AMENDMENT TO  
PUBLIC AGENCY PERMIT

Project Title: Chevron El Segundo Groin and County Outfall Extension

Project Description: Construction of a 900-foot long groin to protect against damaging erosion to Chevron's El Segundo Refinery Marine Terminal. Project includes extension of the Los Angeles County Grand Avenue storm drain.

ATTACHMENTS TO 'MITIGATION'

FIGURE 2  
 BEACH PROFILE  
 MONITORING  
 POINTS

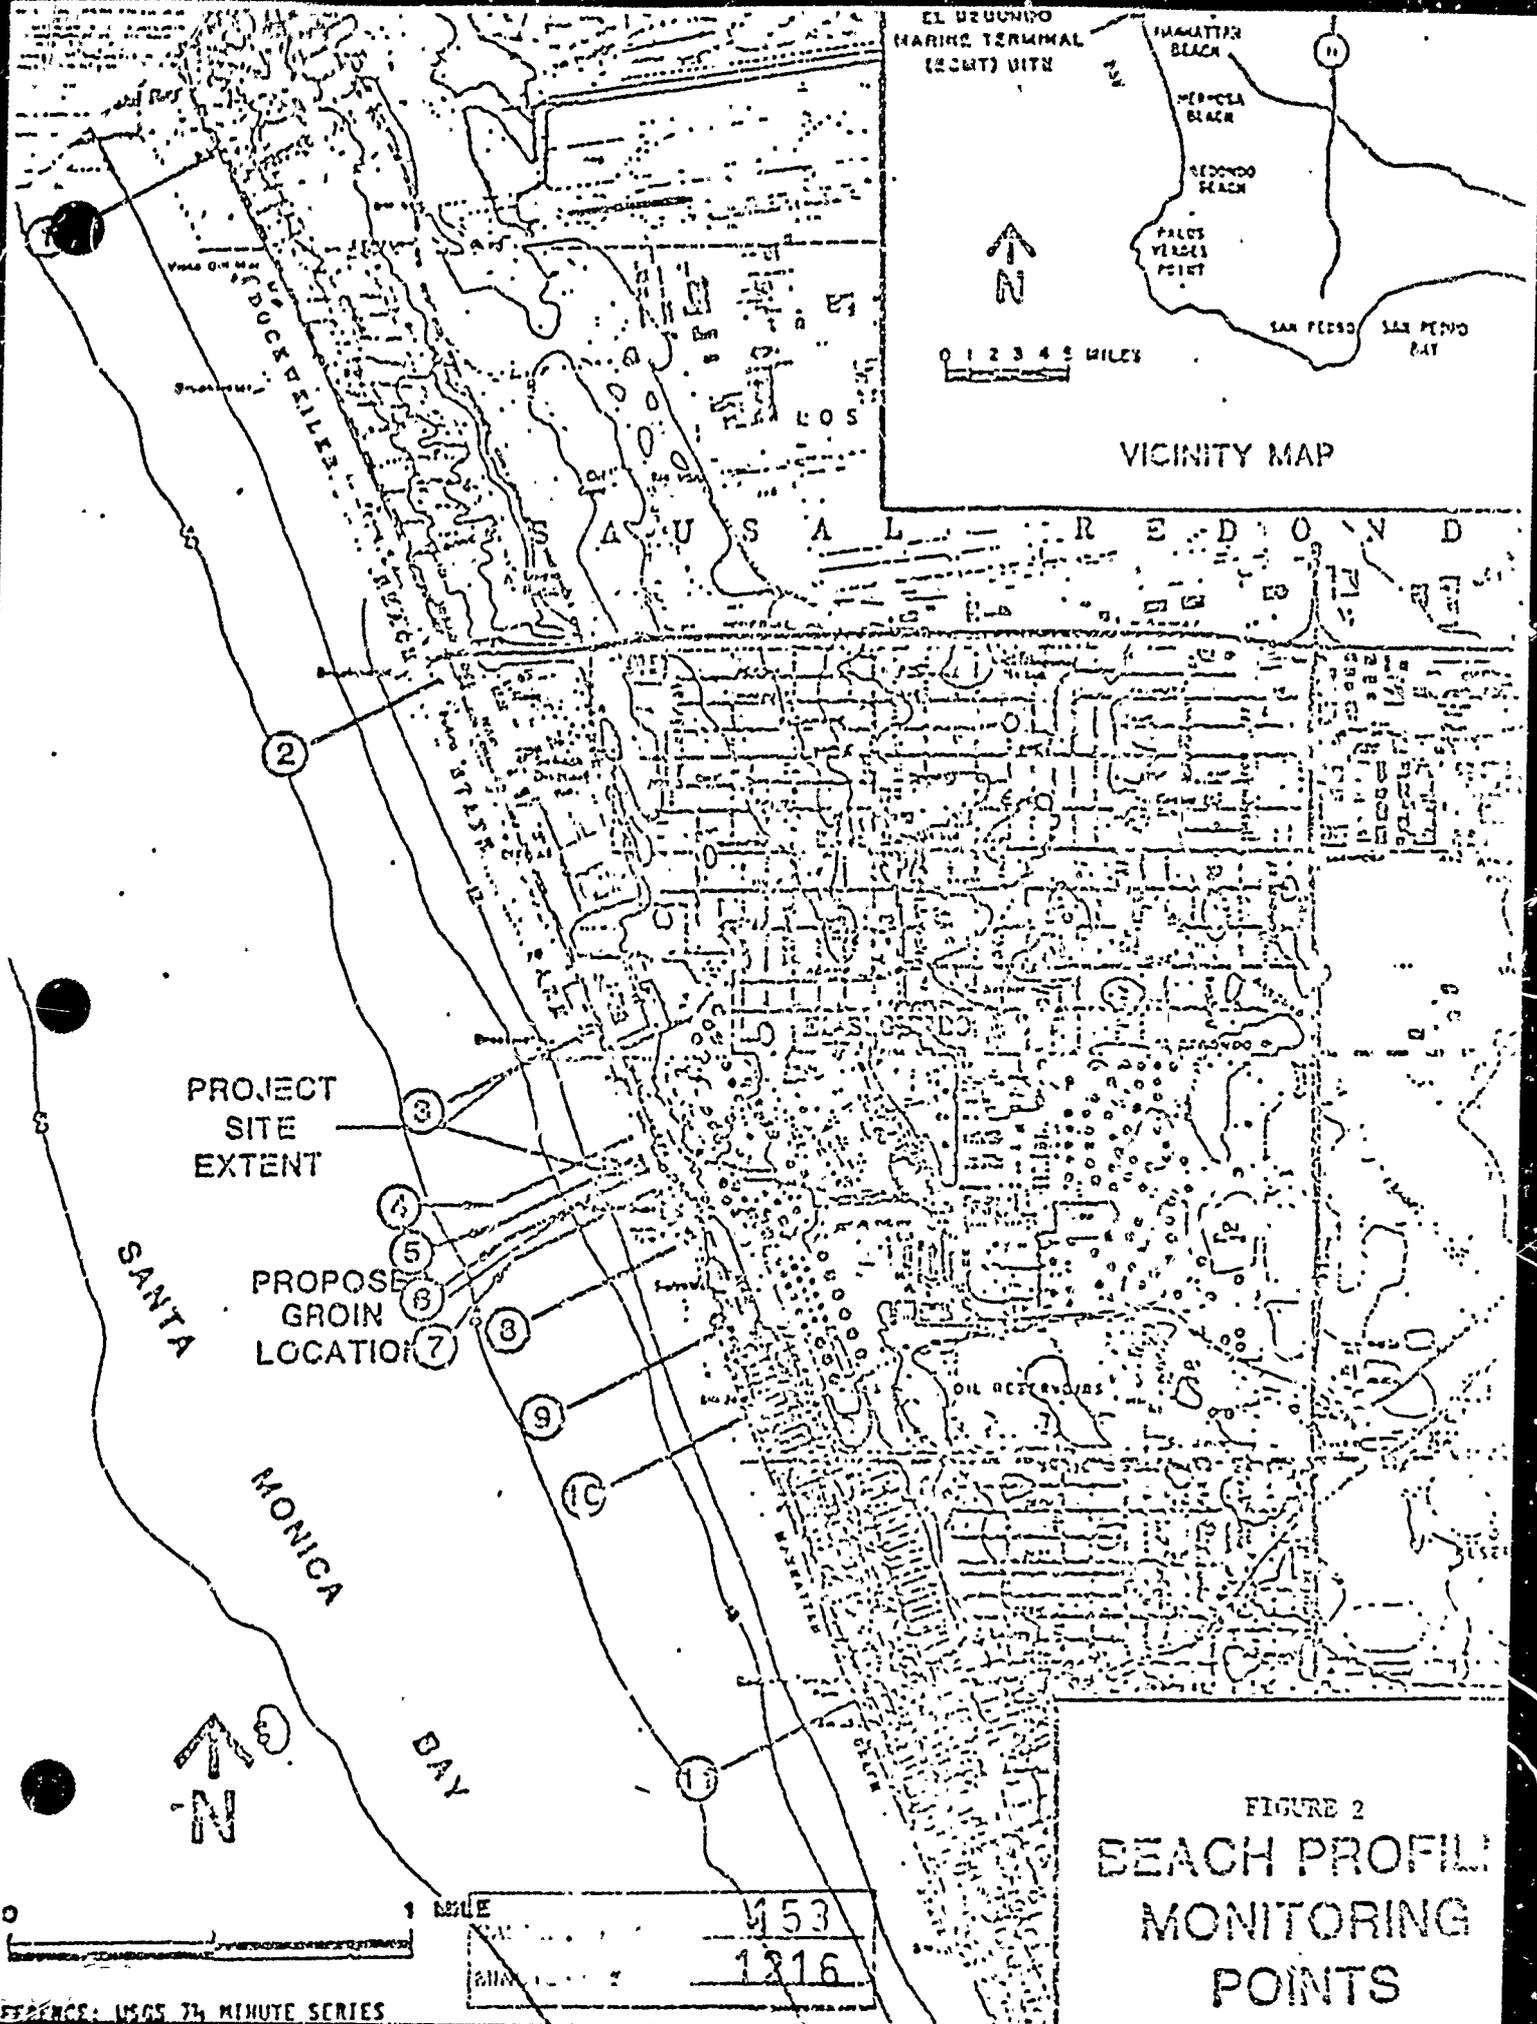
Chevron has developed a monitoring program which addresses down coast erosion and will detect any increase caused by the Chevron groin. The program is based on a survey of twelve (12) beach profiles from Playa Del Rey to Hermosa Beach (See Figure 2). These surveys will be taken semi-annually the years before and after construction and annually in August thereafter. This data will be analyzed by a third party consultant and a report prepared annually for at least five years. The analysis will consist of a determination of sand volume changes from year to year at depths from 0'MLLW to -25' ML. Changes will be compared between above groin profiles and below groin profiles. In the unlikely event that the consultant determines that a direct cause-effect relationship does exist between the presence of Chevron's groin and downcoast erosion, Chevron will take remedial action. Such action would have to be determined at the time, but could include beach nourishment, breach of a portion of the groin, a sand bypass system or repair of erosion-damaged property. The percentage of erosion attributed to the groin would establish the percent financed by Chevron. Chevron believes the design is sound, and that the annual analysis will substantiate this.

FIGURE 3

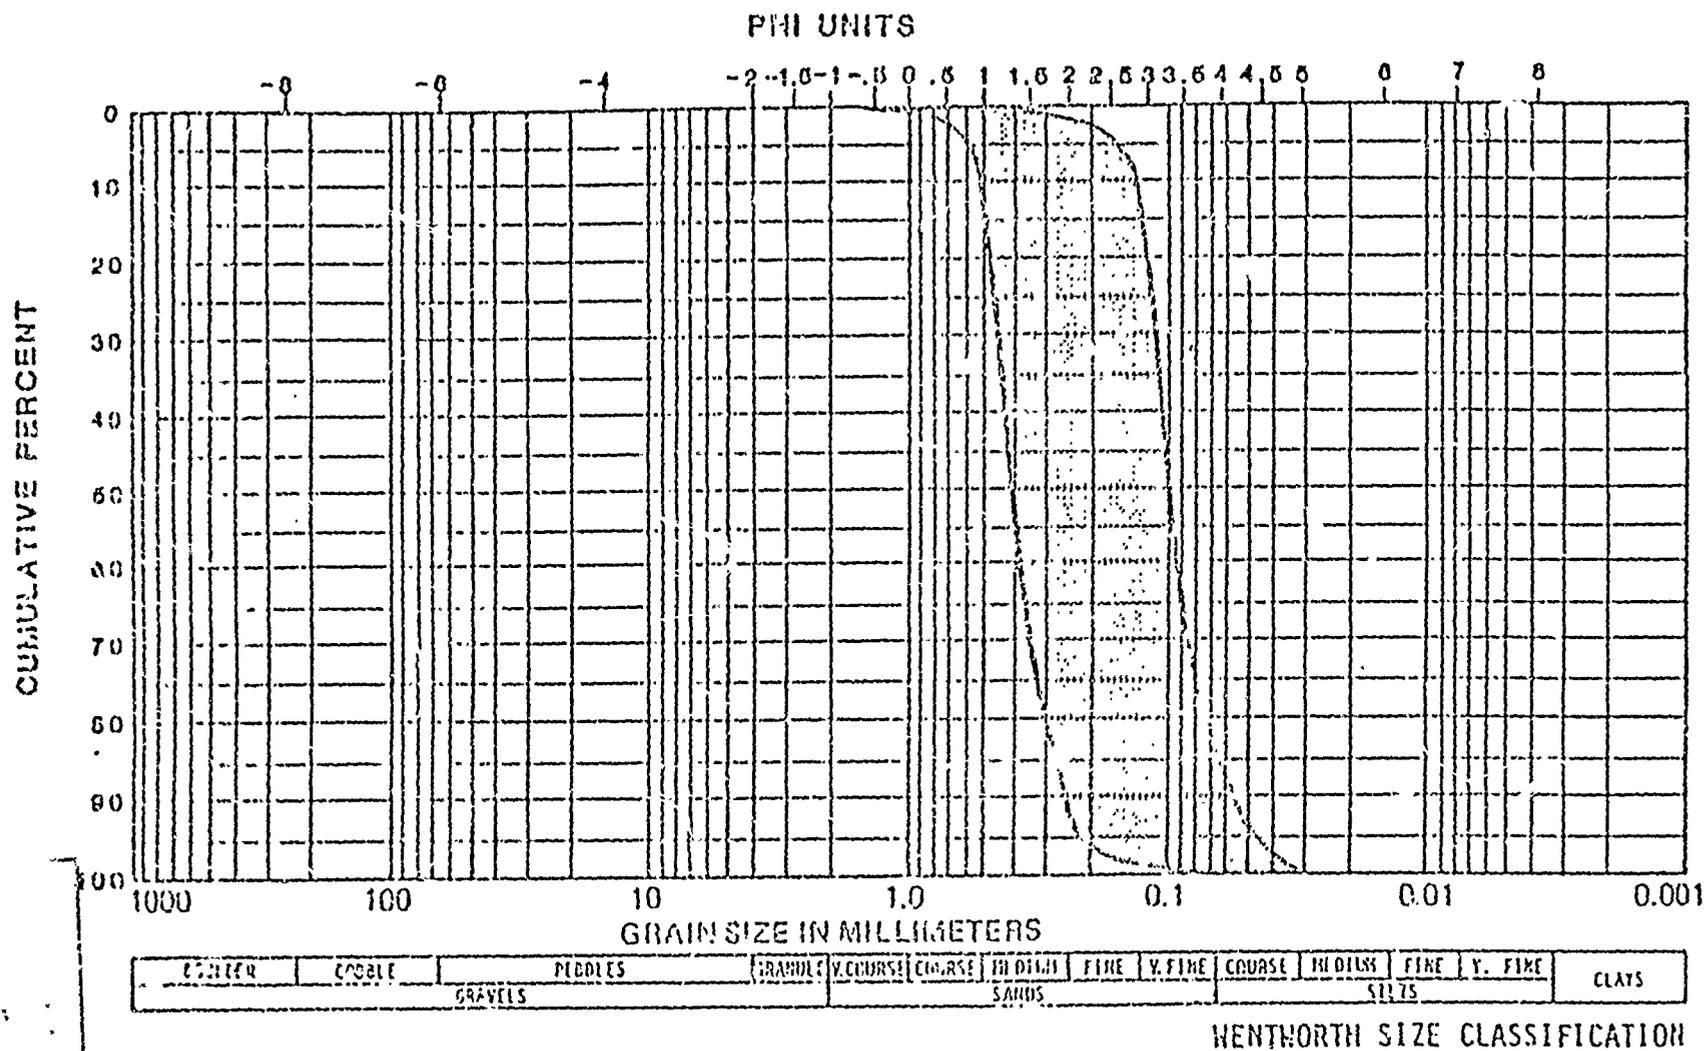
Based on results of grain size analyses from samples collected along beach profiles 1 and 2, grain size envelopes were developed (Figures 3 and 4). Results of the grain size analyses performed on channel samples removed from vibracores VC-1 through VC-4 and VC-12 through VC-23 were used to develop a composite grain size curve. Each sample interval from cores VC-1 through VC-4 and VC-12 through VC-23 was weighted according to its length in relation to the total length of recovered core. For each size class, the composite was calculated by the summation of percent by weight multiplied by the footage of each interval divided by the total footage sampled for all locations. Figure 5 shows the composite grain size curve for vibracores VC-1 through VC-4 and VC-12 through VC-23.

FIGURE 6

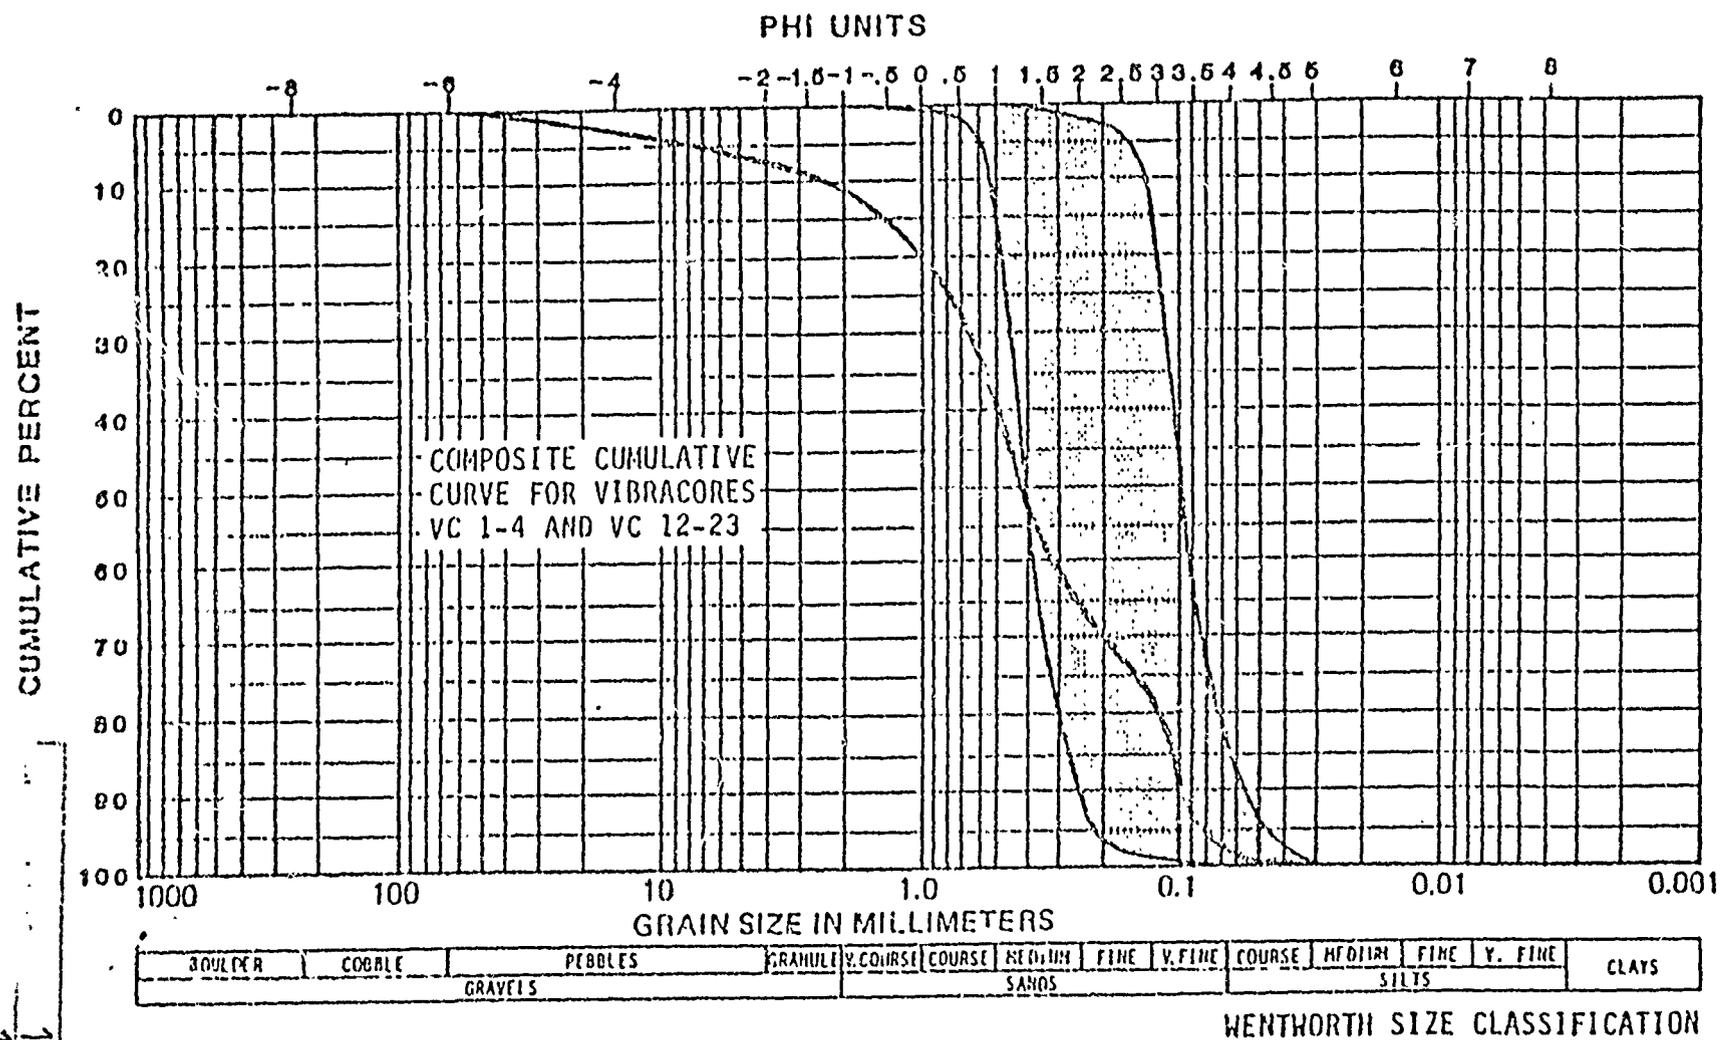
Figures 6 and 7 show this composite grain size curve in relation to the grain size envelopes developed for beach profiles 1 and 2. Although these figures show that some of the material within the proposed borrow area is coarser than that found along the receiving beach, this is not in violation of COE guidelines. The coarser components of sediments in the proposed borrow area are less than 60 millimeters in diameter and are not expected to present any adverse aesthetic impacts along the receiving beach. Figures 6 and 7 clearly suggest that sediment contained within the proposed borrow area is compatible with sediments on the receiving beach according to COE guidelines.

FIGURE 8: ESTIMATED OCEAN BOTTOM DEPTHS, A COMPARISON

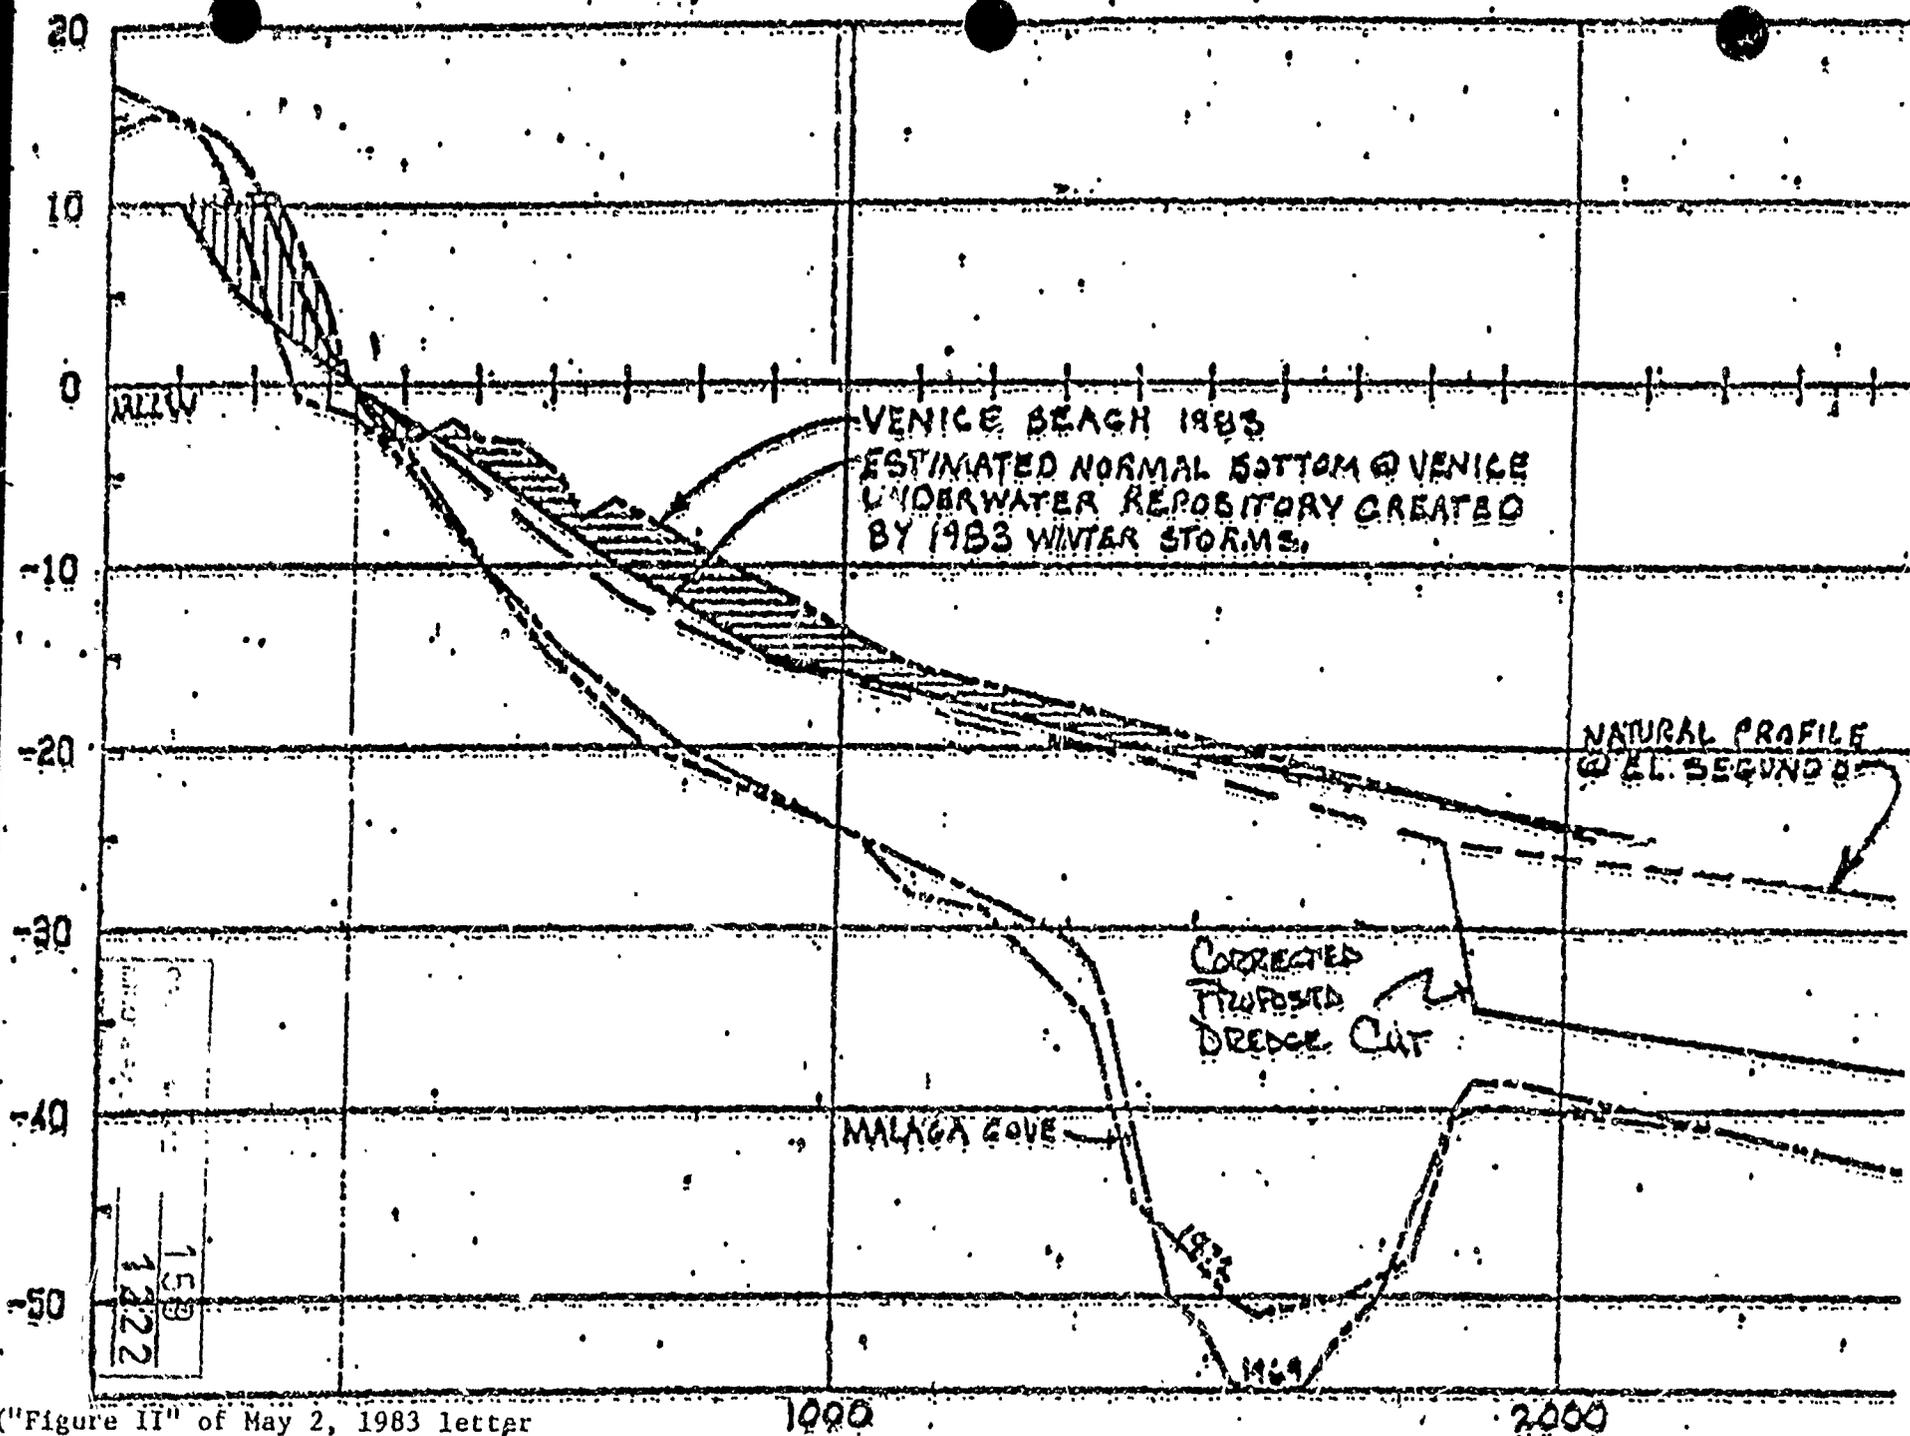
Concern has been expressed that the dredge borrow site is located too close to shore and will fill in with material drawn offshore from the beach fill. This would cause a deficit in sand carried in the longshore transport system, which would potentially result in increased down coast erosion. In support of this concern Los Angeles County Engineer - Facilities Department prepared several profiles depicting the Redondo-Malaga Cove dredge depression, the proposed El Segundo dredge depression and pre and post 1983 storm profiles near Venice beach (see Figure 8). In preparing the Figure, the County states that the Initial Study presents conflicting data on the inshore limit of the proposed dredge source. Since this data was used to formulate their conclusions, the following paragraph is presented to clarify the data.

The County's report refers to Page 64 of the Initial Study which indicates -25 ft MLLW at 1250 feet, while Figure 19 (from Initial Study) indicates -30 MLLW. The inshore limit of the proposed dredge cut is defined as -25 ft. MLLW. The length of the beach parallel dredge cut (north to south) is approximately 1,250 ft. This is not the distance from the shoreline (which presently is approximately 1,500 ft from the shoreline to the inshore limit of the dredge cut). The County selected Figure 19 from the Initial Study, to base their profiles of the proposed El Segundo dredge cut. Since this is a schematic drawing, scaling data from this figure is inappropriate. Chevron has have revised the County's Figure II (see Figure 8 of this report) to reflect a correct representation of the proposed dredge cut profile.

As shown on Figure II, a considerable amount of material has been drawn offshore Venice beach as a result of the 1982/1983 winter storms. The seaward limit of this storm includes offshore movement of material is shown in Figure 8 to be approximately -22 ft MLLW and only a small fraction (5 percent) of the total volume is seaward of -30 ft MLLW. Since the dredge cut will be seaward of -25 ft MLLW, there is little chance that any significant offshore transport of material will be drawn into the dredge depression by storm events and not returned to the active littoral zone. The profiles presented by the County for Venice beach are typical of profiles we have examined in Santa Monica Bay that all indicate the seaward limit of active on-offshore littoral movement is in the range of -17 to -22 ft MLLW. The shoreward limit of dredge cut was selected after examination of historical beach profiles, wave data and operational limits of available dredging equipment.
